Tender Period Addendum 03

Town of South Bruce Peninsula – New Town Hall Offices

Re: Architectural, Mechanical, Electrical, & Structural Revisions

DESCRIPTION: 400 Series – 400 Bike Rack: H.S. Steel Tube, Surface Mount, 11 Bike Configuration ✓

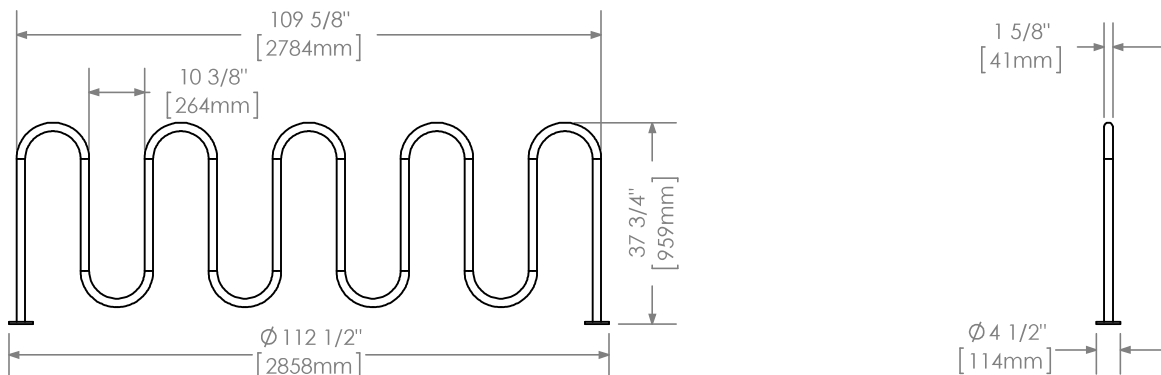
- .25 **Contractor Question:** "Please provide specs for the bicycle rack, benches or flagpole."
- .1 **GMDA Response:** Benches are deleted, flag pole spec has been issued in addendum 01. Bike rack shop drawing provided with this addendum.
